An
Bord
Pleanála

Planning Appeal Online Observation

Case Number / Description
314485

Dublin Airport, Co Dublin

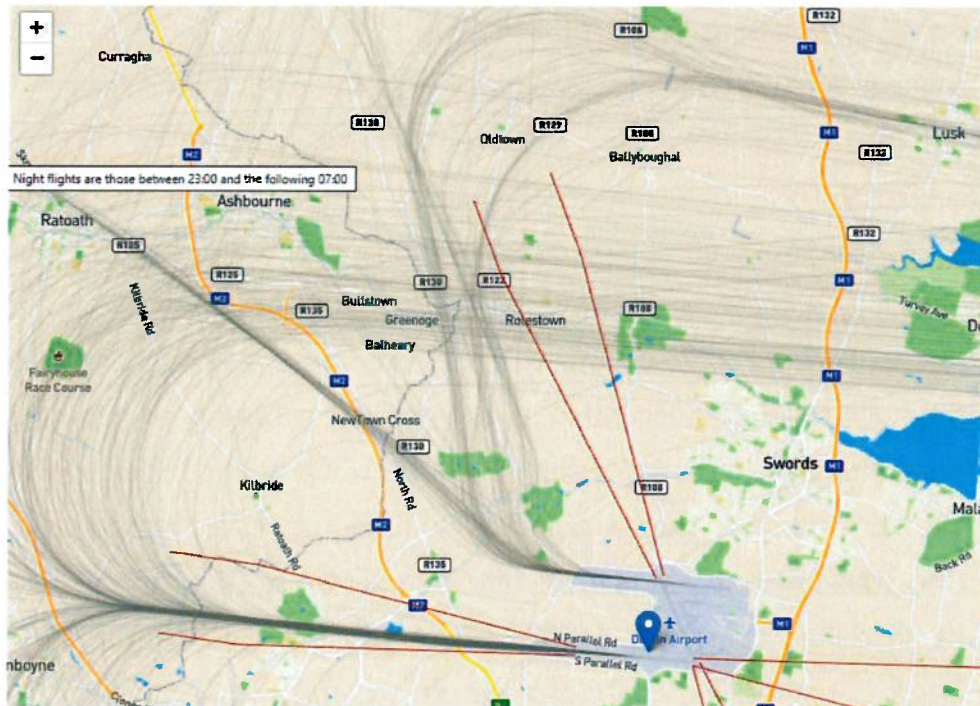
- Flying divergent flight paths on the North Runway for Westerly operations contravening the EIS of 2007
- Divergent flight paths currently in operation do not align with EIAR for this current planning application that is under appeal

- 30-degree divergence was not proposed in the 2016 consultation
- Condition 3 of planning does not allow for dual runway departures under Option 7b
- Flight paths used in Insulation Scheme approved by Fingal County Council in 2016, based on 2007 planning permission, show straight out operations

- Departures on North Runway on August 25-27th and all dates of westerly departures since opening are showing divergent routes contravening the planning permission from 2007
